SEWER RENEWALS FY25 CONSTRUCTION SERVICES

REQUEST FOR PROPOSAL (RFP) #2024-015876

ADDENDUM NO. 2

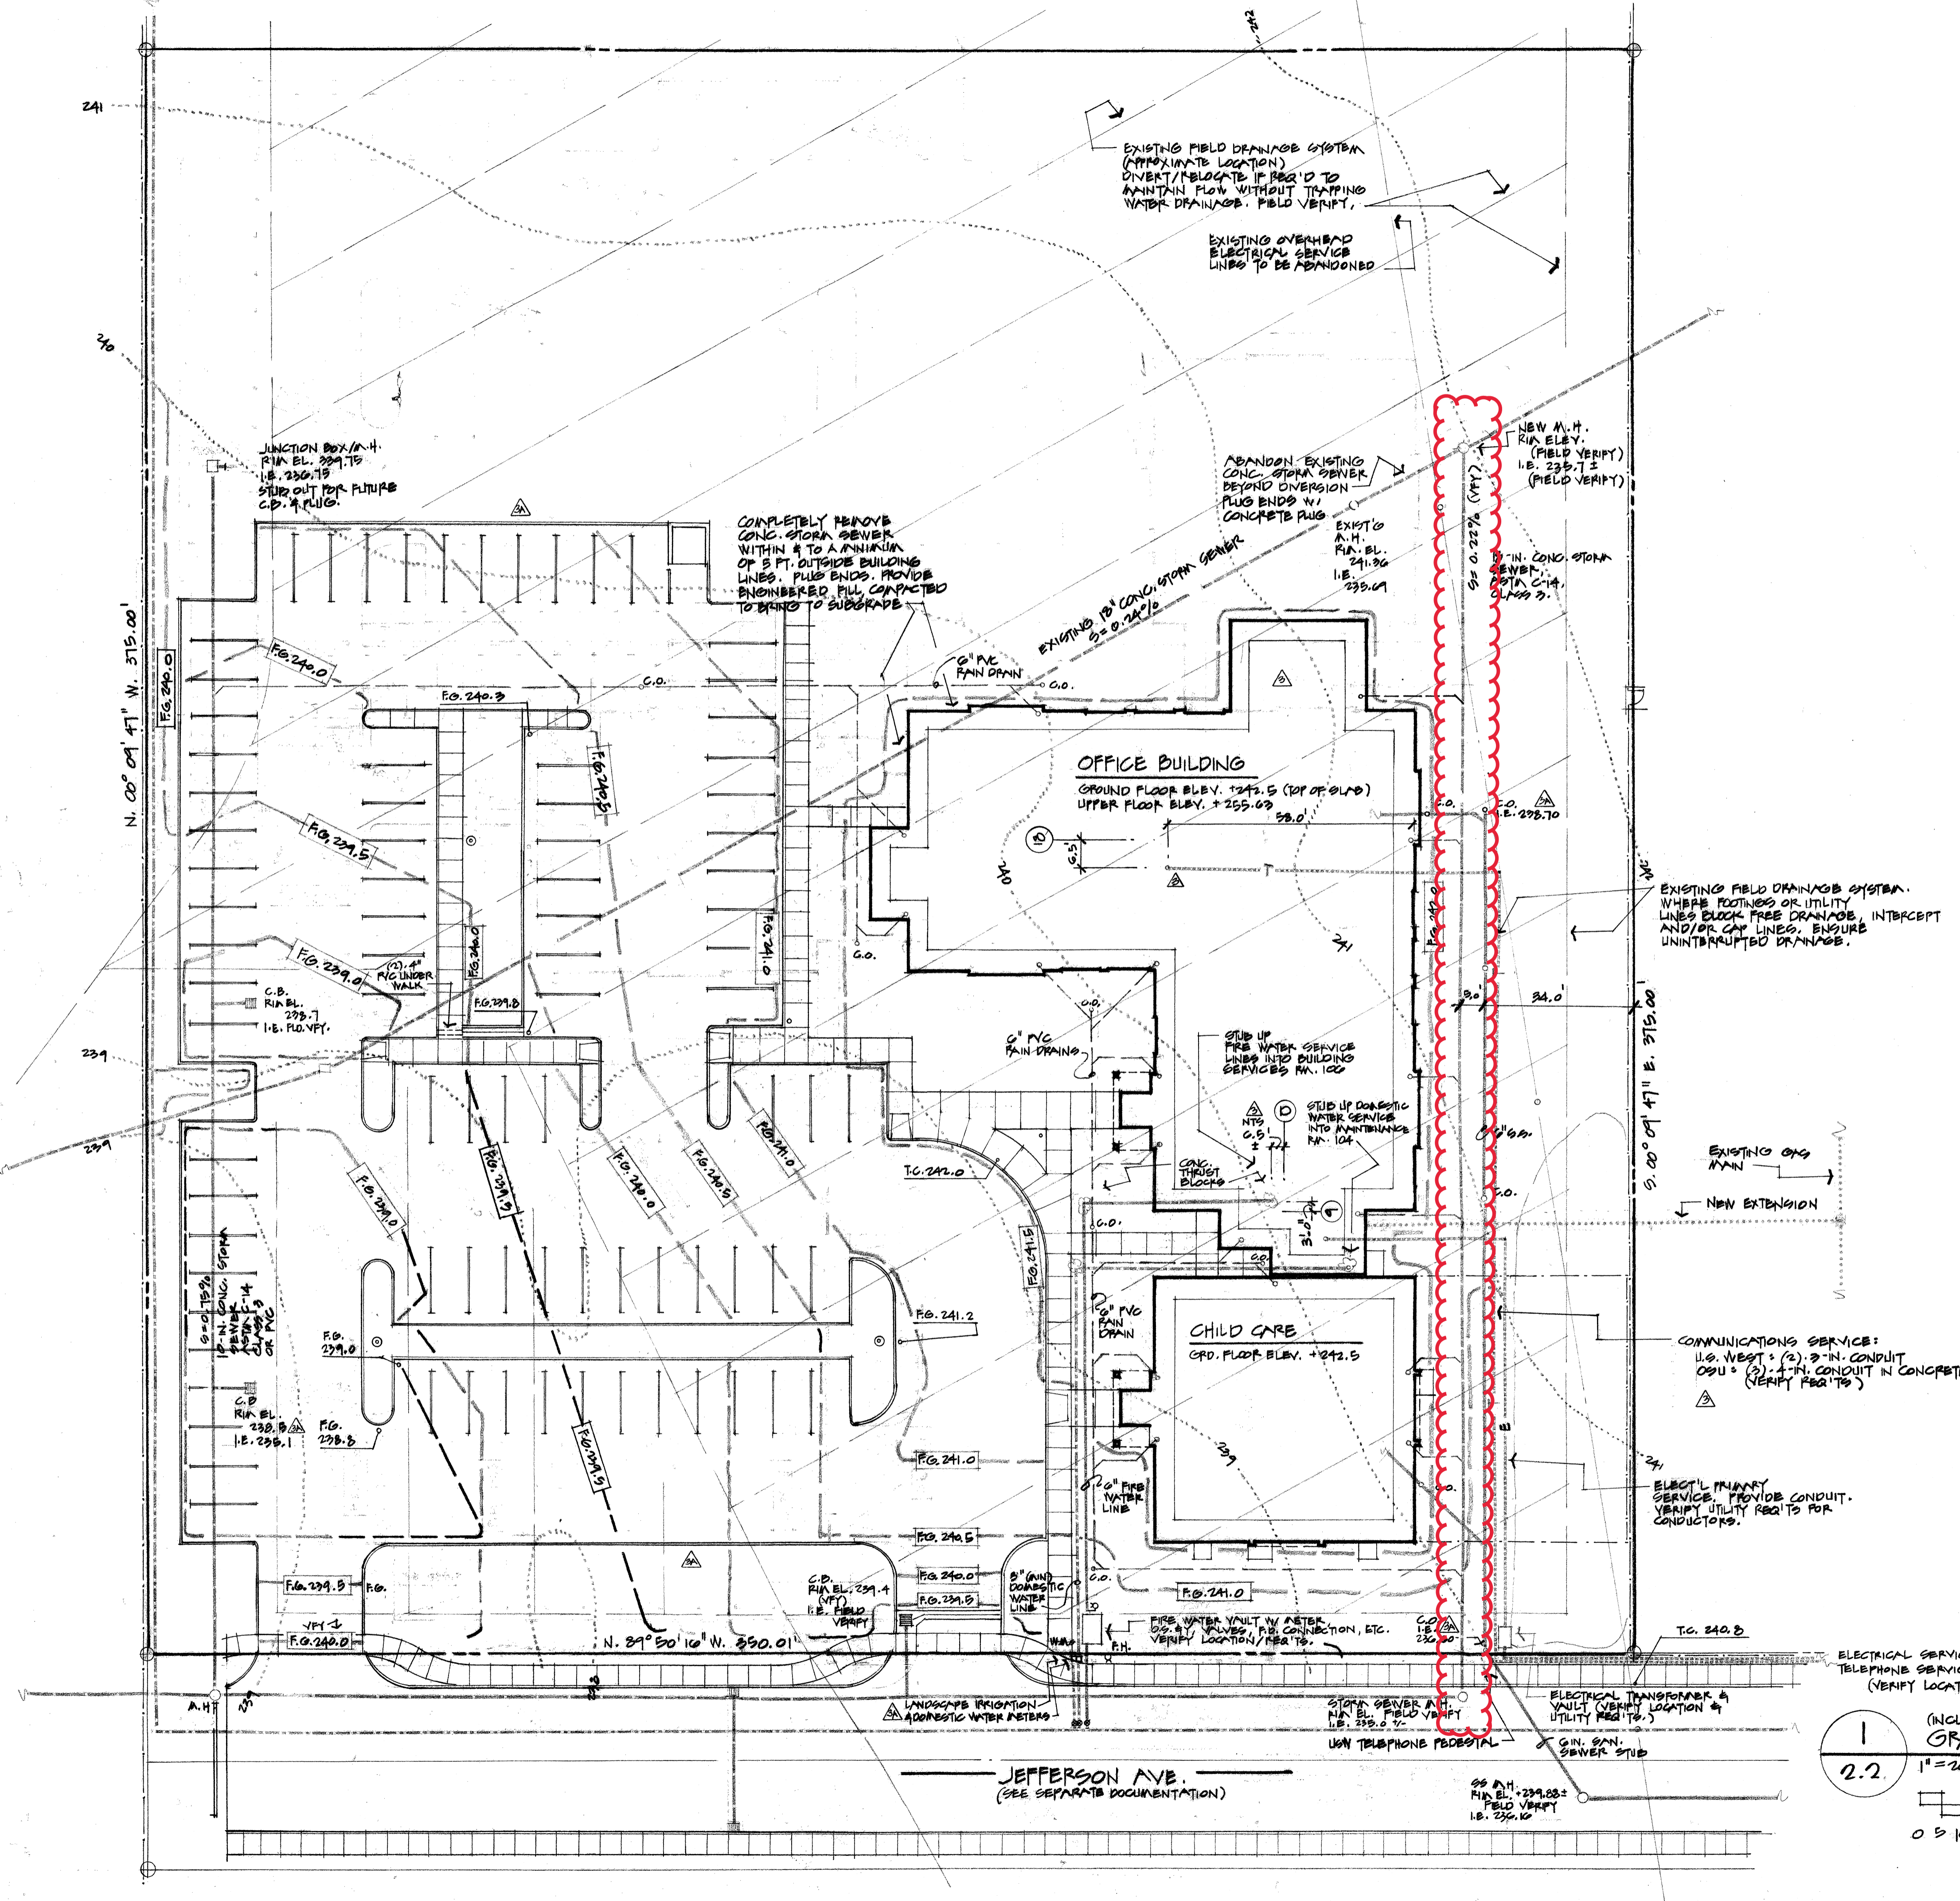
Item 2 Q: What is the depth of the pipe and manholes, and will there be an addendum with this information?

A: Included with this addendum is a marked-up Site Plan identifying depths, or approximate depths. Also included is a utility plan for the Jefferson Street Building that identifies some roof drain downspout connections.
